MPC Paper No. A/H6/87A
For Consideration by the
Metro Planning Committee
on 18.1.2019

APPLICATION FOR PERMISSION
UNDER SECTION 16 OF THE TOWN PLANNING ORDINANCE

APPLICATION NO. A/H6/87

<u>Applicant</u>	Century Shiner Limited represented by Kenneth To & Associates Limited
<u>Site</u>	4-4C Tai Hang Road (Part) and adjoining Government land, Tai Hang Road, Hong Kong
<u>Site Area</u>	About 2,203.9m ² (including about 2,090.4m ² (94.8%) of Government land)
<u>Lease</u>	Inland Lot No. 7426 (a) 75 years from 22.9.1958 (b) restricted for private residential purposes with a Right of Way to and from the lower portion of Tai Hang Road (c) maximum GFA of 2,928m ² (d) the Lessee shall maintain the slope within the Green Hatched Black Area (GHBA)
<u>Plan</u>	Draft Causeway Bay Outline Zoning Plan (OZP) No. S/H6/16
<u>Zoning</u>	"Green Belt" ("GB") (about 53%) "Residential (Group A)1" ("R(A)1") (about 36%) - maximum building height (BH) of 115mPD "Residential (Group B)" ("R(B)") (about 5%) - maximum plot ratio (PR) of 5, and maximum BH of 30 storeys including carports 'Road' (about 6%)
<u>Application</u>	Proposed 'Flat' use (access road for residential development and pedestrian link)

Figure 3.1 (rev.) The Proposed Access Road and Pedestrian Link

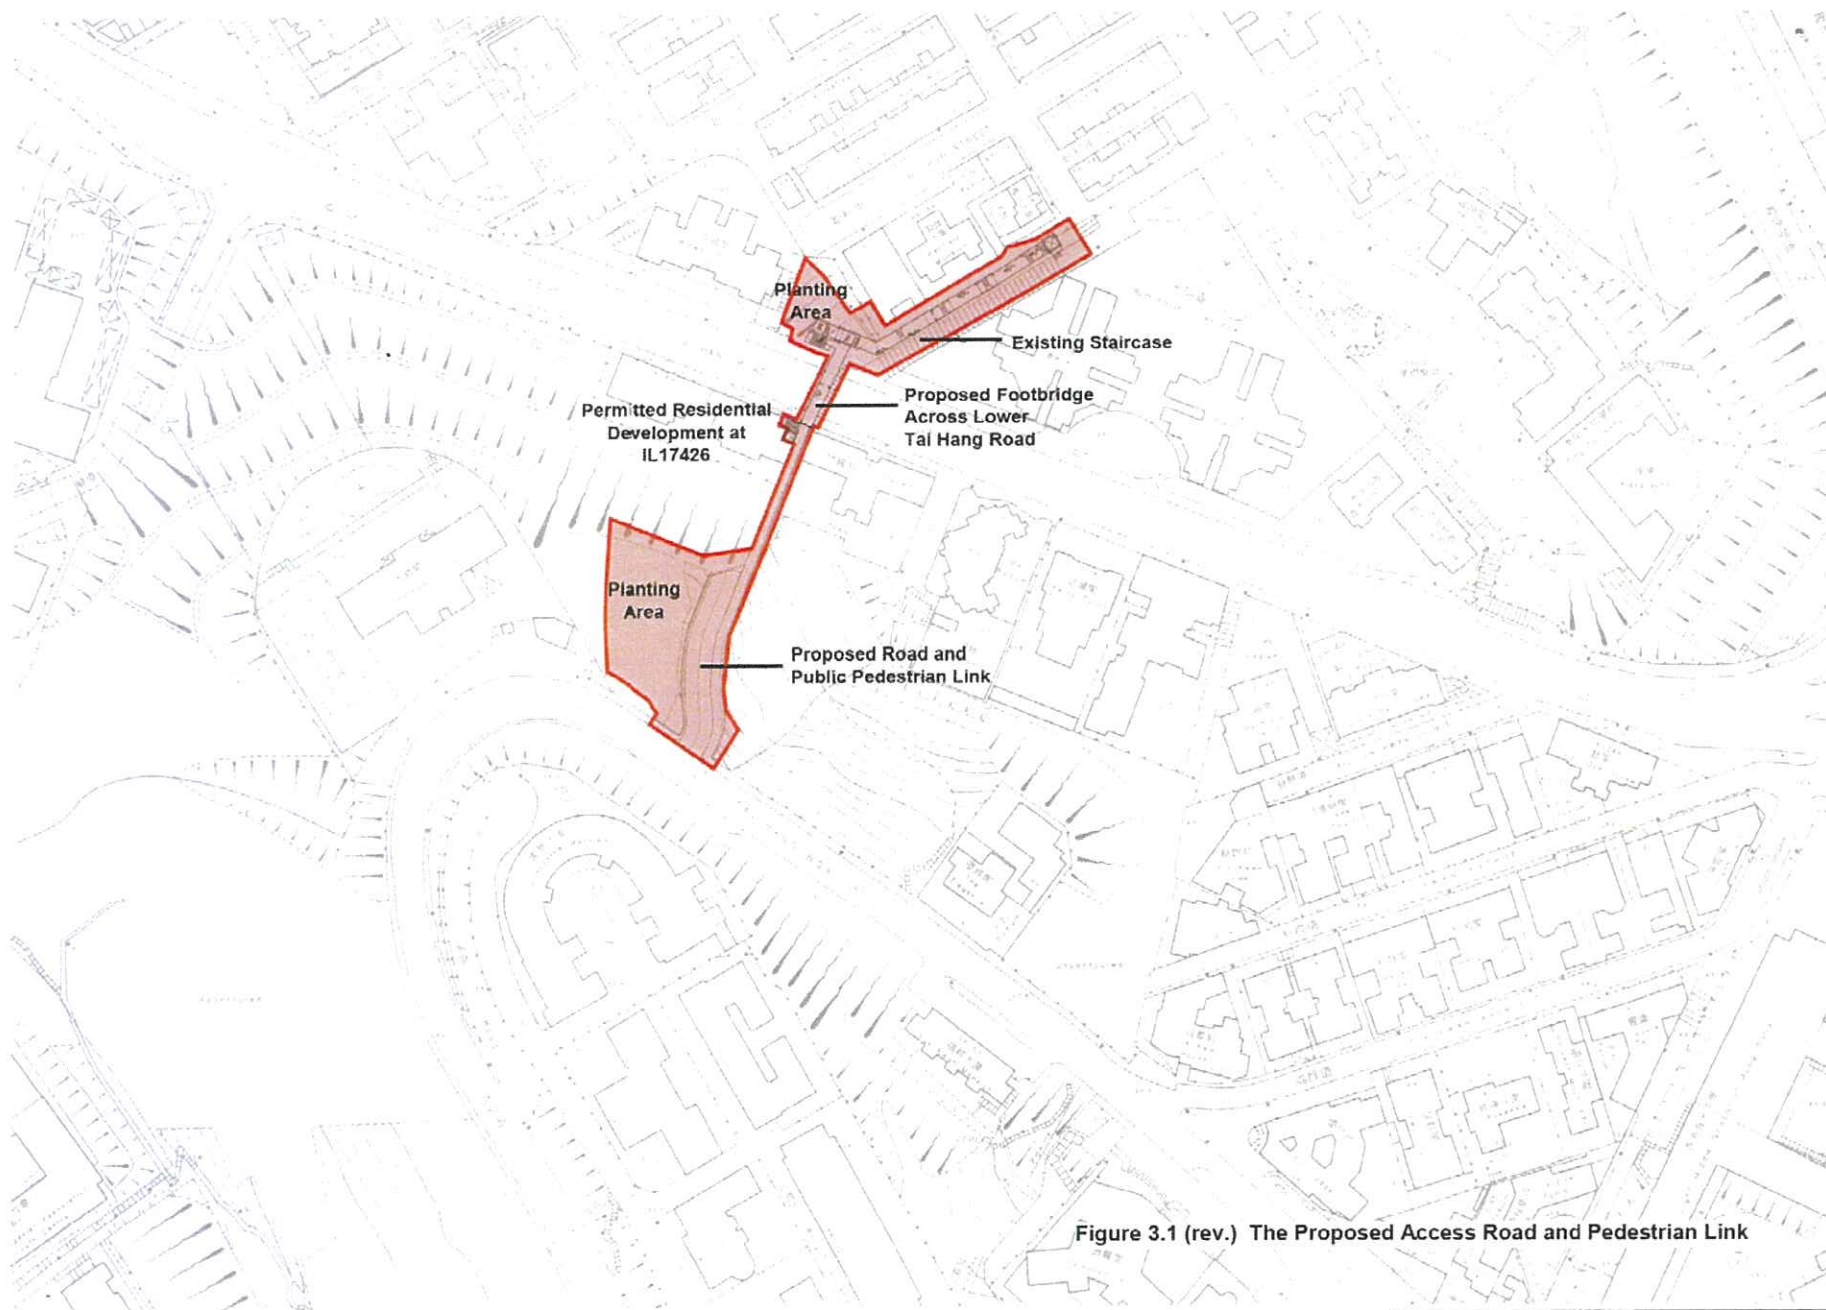
- (d) discrepancies are found for the width of the proposed access road as presented in Section 3 (6m carriageway & 1.6m footpath), Figure 3.1 in Appendix 1 (6m carriageway & 2.0m footpath) and Figure 3.1B in Appendix 4 (6m carriageway & 2.5m footpath).

FIGURE 3 - LONG SECTION OF PROPOSED PEDESTRIAN WALKWAY SYSTEM
A3-1:250

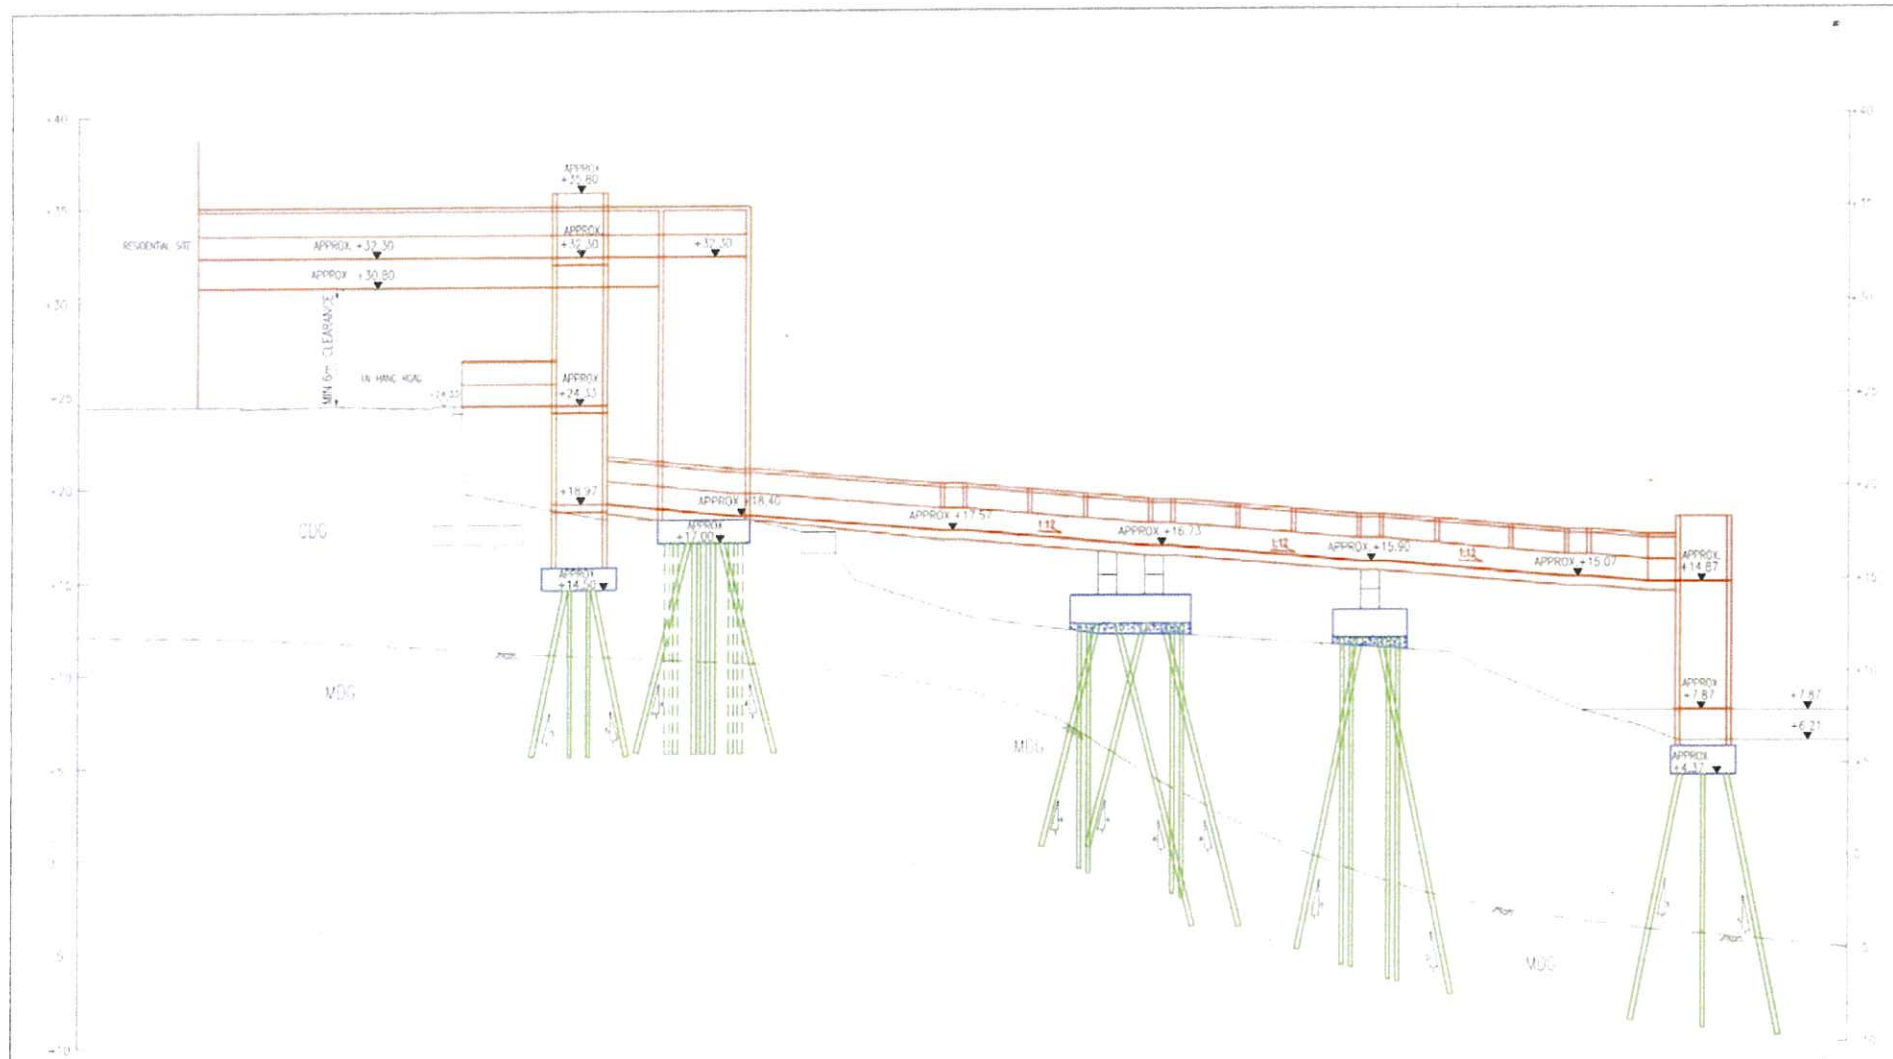
- (i) there are inconsistencies regarding the bottom level of pile cap supporting the column of the pedestrian walkway located at the existing platform in front of retaining wall feature no. 11SE-A/R217 as shown on Figure 3 (+16.5mPD) and Figure 4B (+17mPD). In conjunction, please clarify whether excavation and lateral support works are required for the construction of such pile cap. If affirmative, the effect of the proposed works to the stability of the existing slopes and retaining walls should be duly assessed;

繪圖
DRAWING
A - 4a

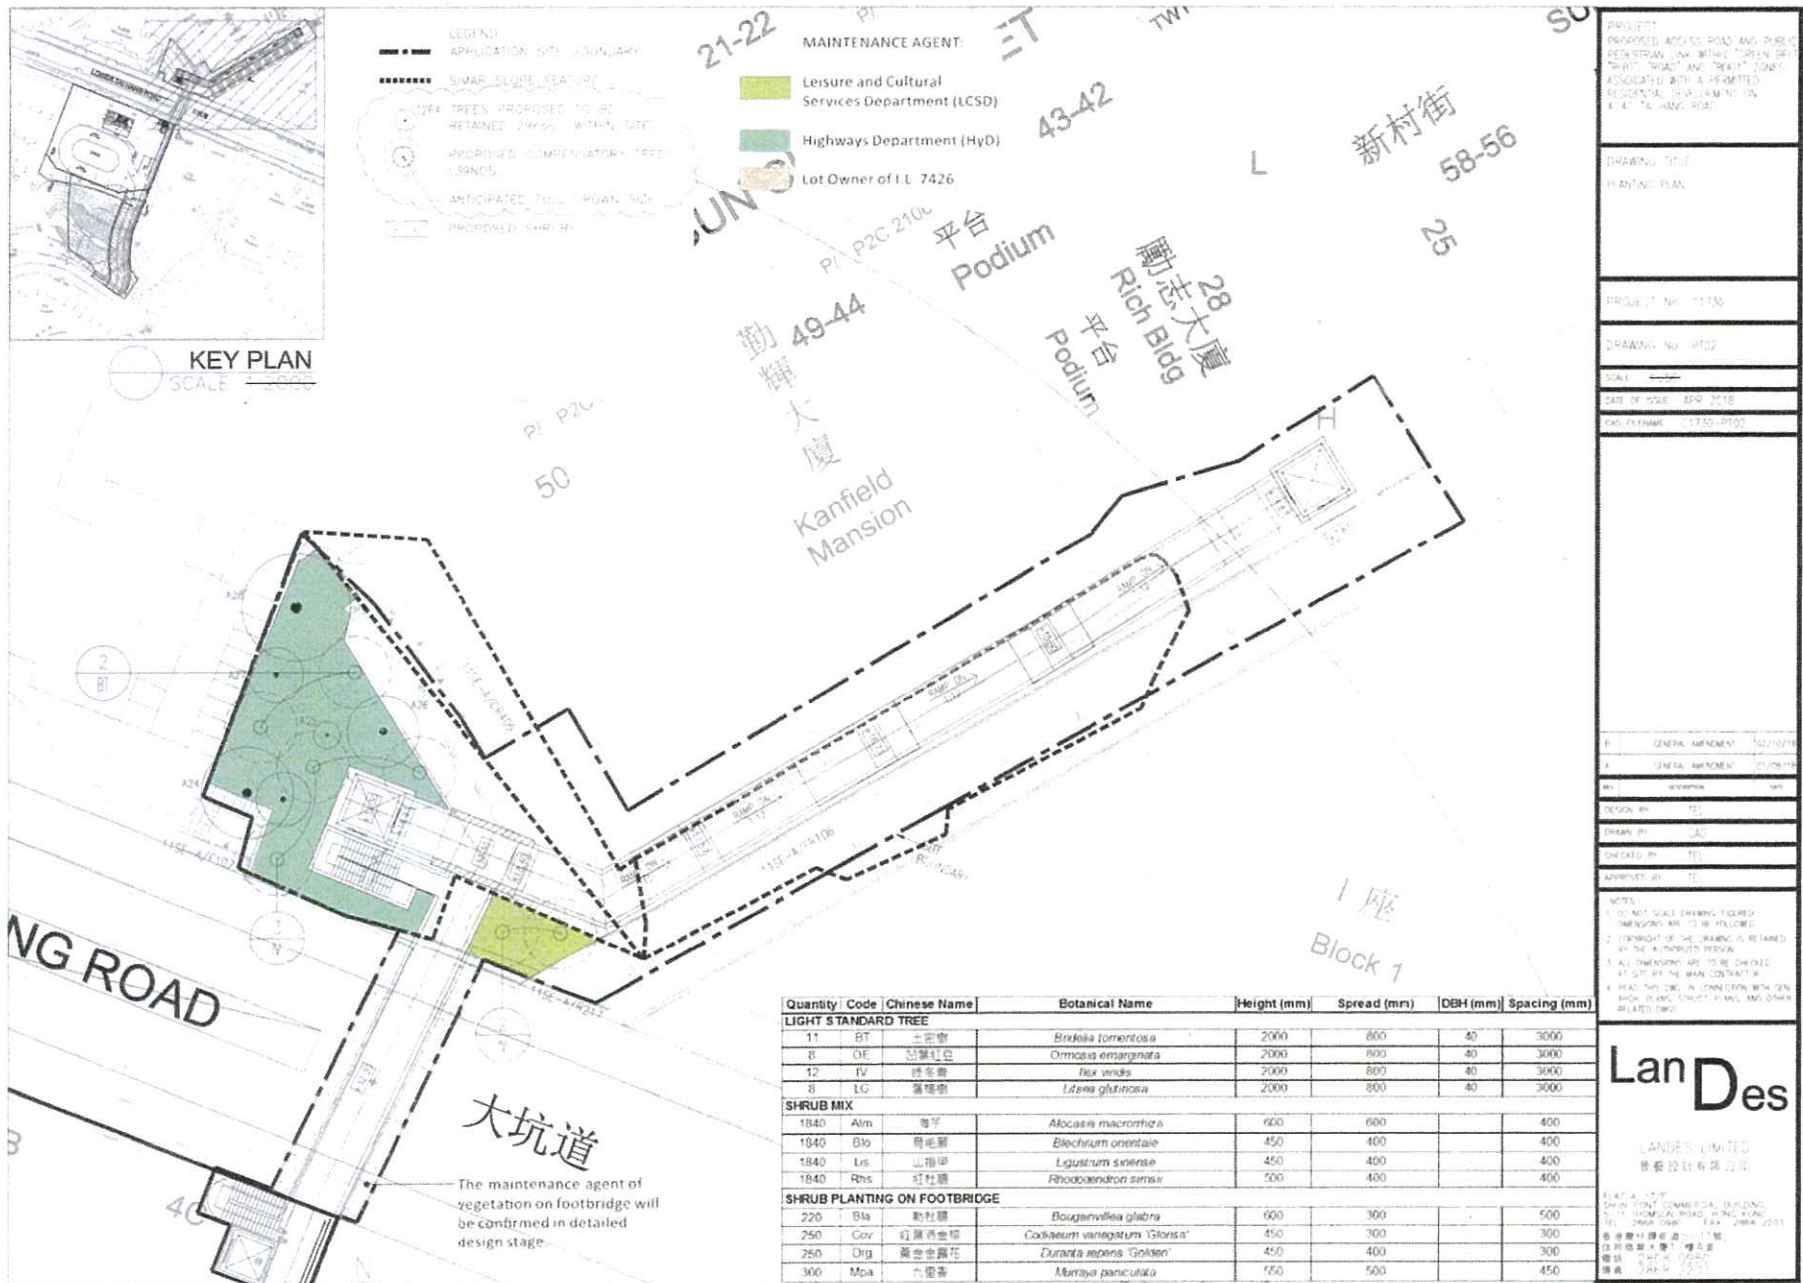
- (h) there are discrepancies on the landscape treatment as shown on the photomontage from viewpoint 8 (Drawing A-6g) as compared to the proposed planting plan in Drawing A-4a. The applicant should clarify and revise the photomontage. Furthermore, an assessment of the visual impact from viewpoints 7 and 8 as per Drawings A-6f and A-6g has yet to be submitted; and

繪圖
DRAWING
A - 7

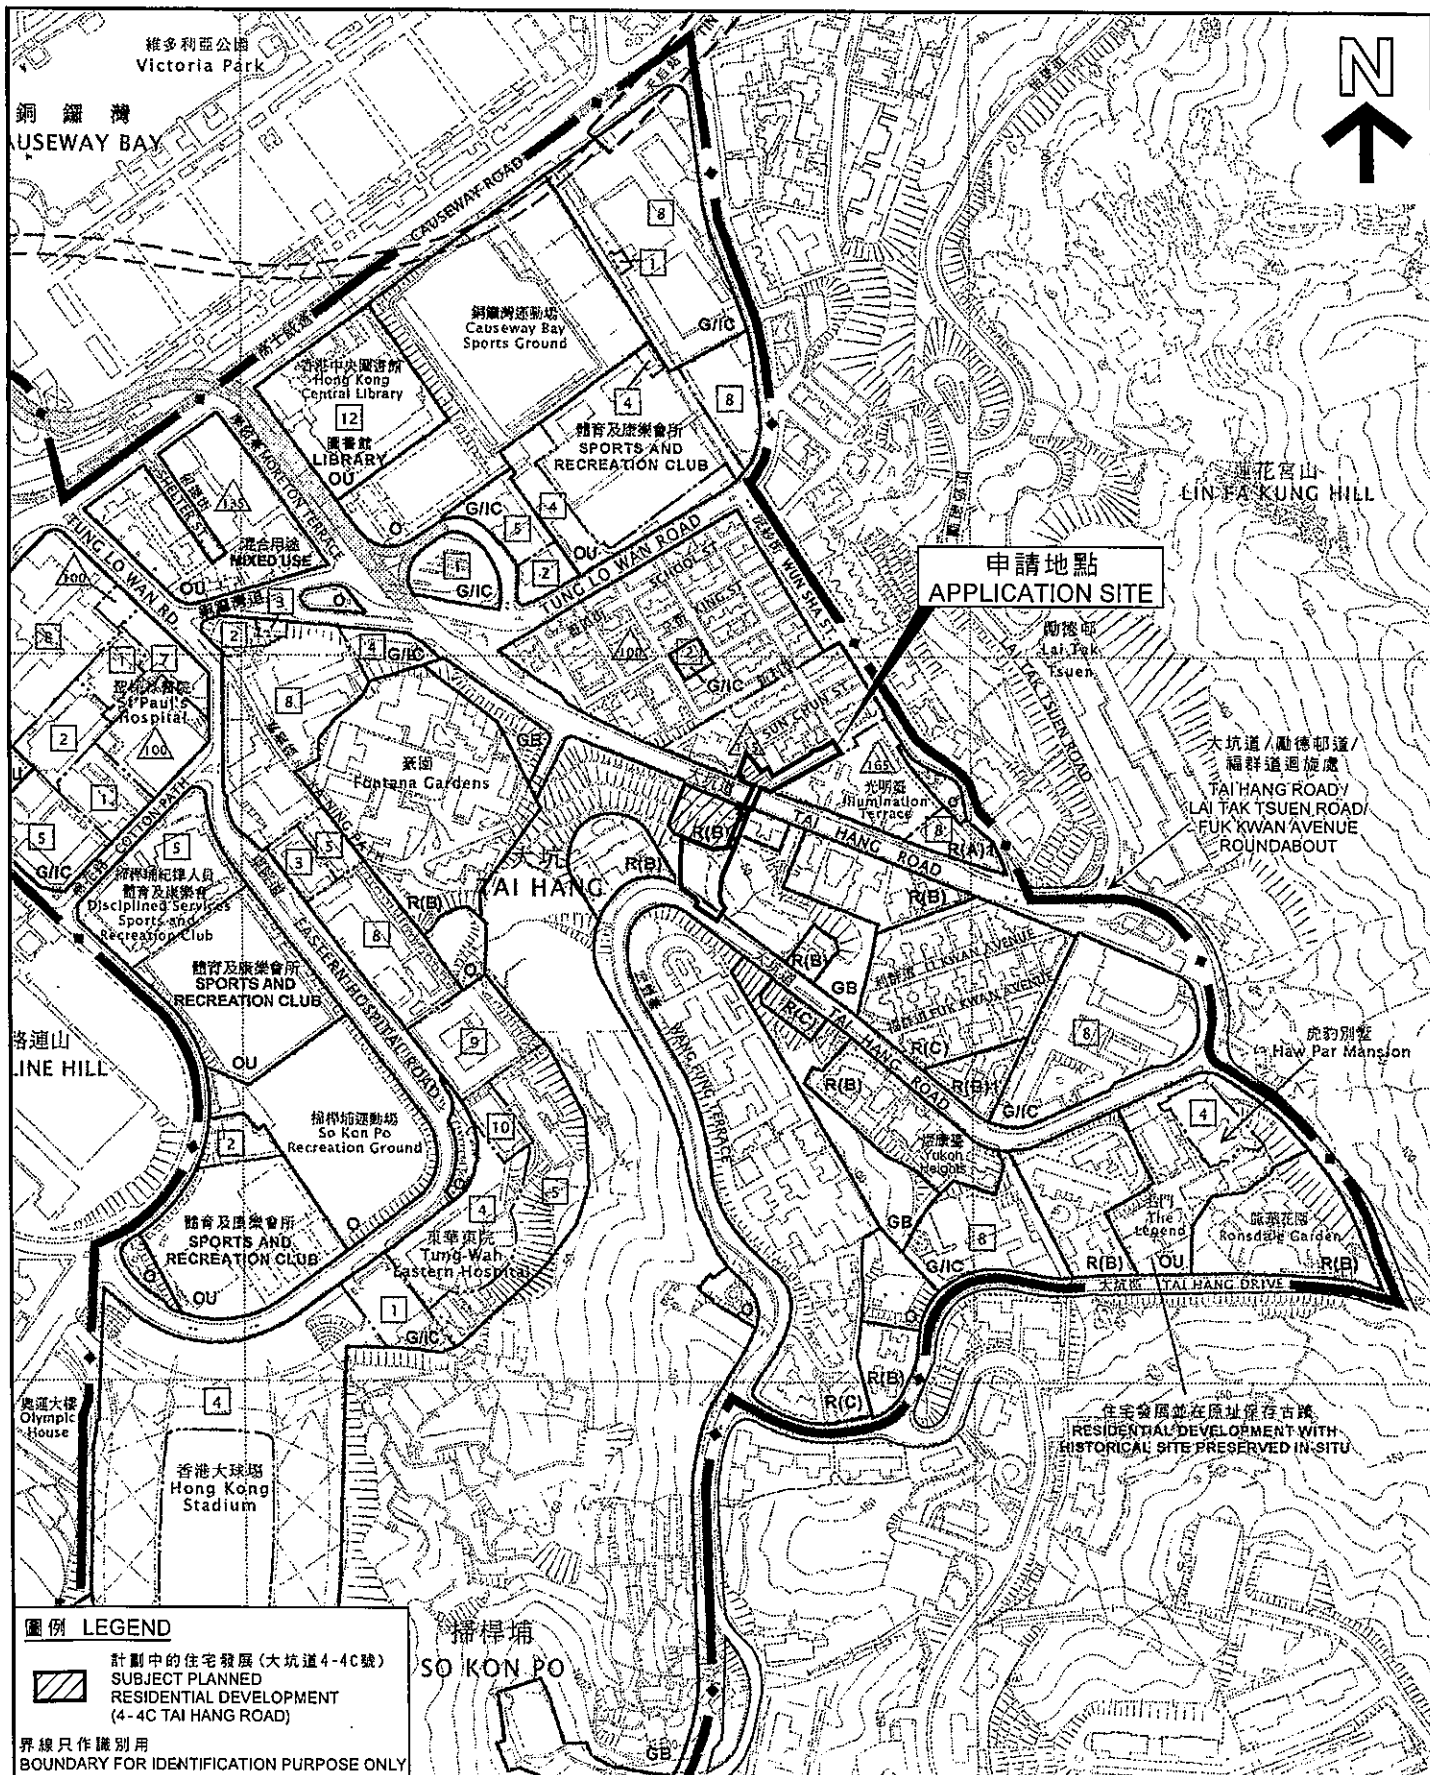
- (g) the site has specific constraints and access only from lower Tai Hang Road will not be able to support a scheme with adequate car parking and load/unloading facilities as well as building services in accordance with modern standards (**Drawing A-7**);

- (b) the necessity of the proposed access road depends on whether there are other practical solutions to overcome the geotechnical and other constraints for maintaining a vehicular access at lower Tai Hang Road. The conclusion of technical infeasibility of maintaining a vehicular access only at lower Tai Hang Road is based on geotechnical constraints, on which TD is not in the position to comment. The applicant should provide justification, to the satisfaction of the Buildings Department (BD) and the Civil Engineering and Development Department (CEDD), to demonstrate such technical infeasibility. Nevertheless, it is noted from FI-1 that the proposed one-way ramp system and the notional car-lift system will only occupy a relative small portion of the subject lot I.L. 7426. Furthermore, from traffic point of view, provided that the lot area can be largely or fully utilized, it seems not impossible to provide vehicular ingress and egress to the lot at lower Tai Hang Road;
